Overview: Mis-Wired door lock connector, field repair required.

Issue: A review of the latest samples of **FTI-TLP4 T-harnesses** has revealed a misplaced trunk output wire in the 6-pin Lock Accessory Connector requiring that the wire be relocated to the correct position, to ensure safe operation when used. **Using the harness without addressing the issue will result in failed trunk/hatch control, and possible damage to the vehicle BCM.**

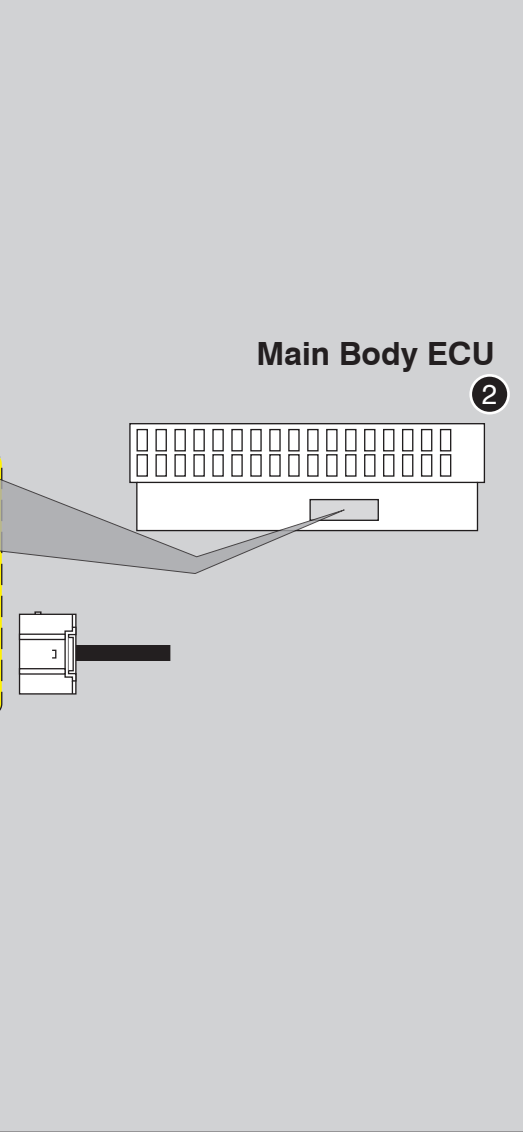
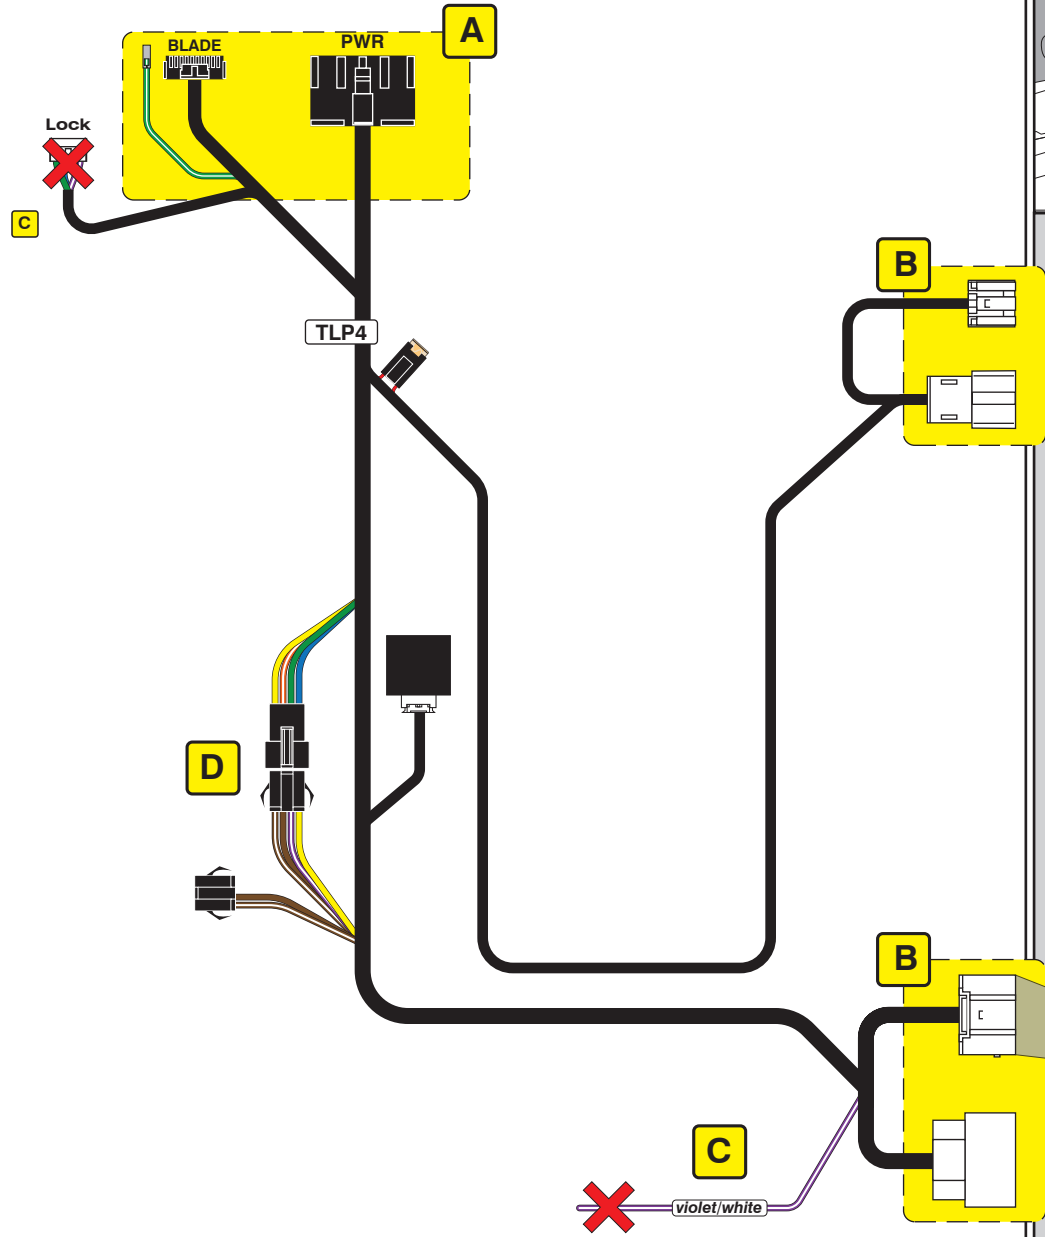
Correction: The harness purple/white wire in the latest production run of FTI-TLP4 harnesses has been inserted in the position normally used for the +12V power connection in the accessory harness. Before completing the installation, the installer must relocate the harness purple/white wire to the correct position, 1 space inward on the 6-pin connector, see illustrations below in Fig. 2.

To relocate the terminal, using a fine pick or Olfa type knife, depress the terminal locking barb and pull the purple/white wire from the connector housing. Once the terminal has been removed from the housing, again using the pick or knife, lift the locking barb about 1/16" (1.5 mm) and reinsert the terminal in the correct position. If upon initial examination of the harness the lock accessory connector looks like the illustration in Fig. 2, no modification is necessary, the wire is in the proper position.
